**PHOTOGRAPHS**

**PHOTOGRAPH #8**

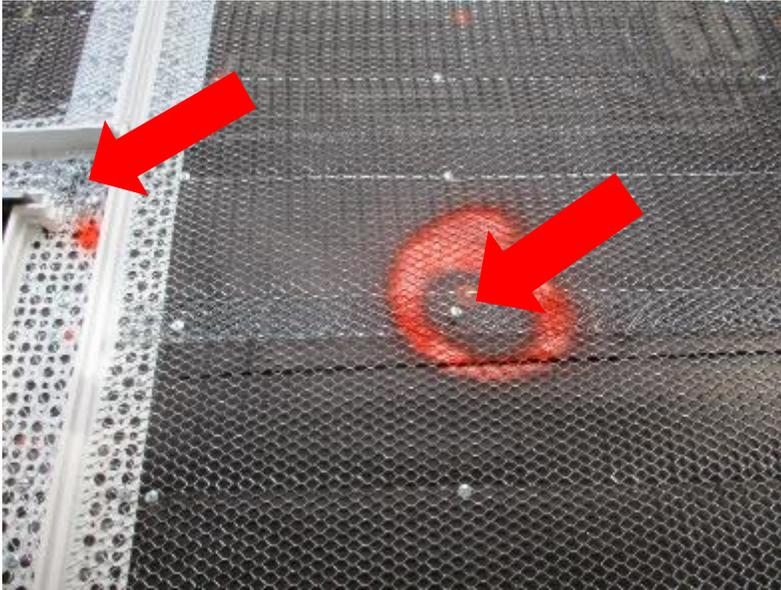
Sub-contractor in process of applying stucco lath and stucco accessories.

**PHOTOGRAPH #10**

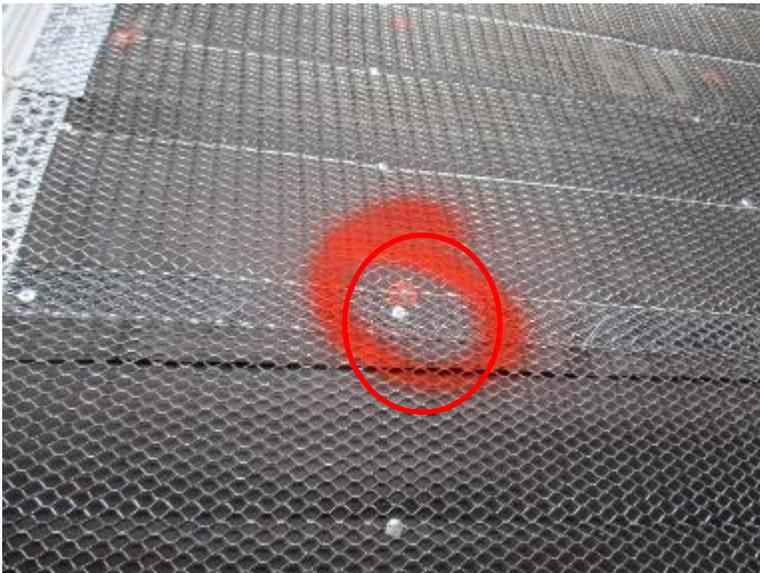
Fasteners not fully embedded at lath,  
marked for correction.

Sub-contractor made corrections to  
fasteners not fully embedded at lath.
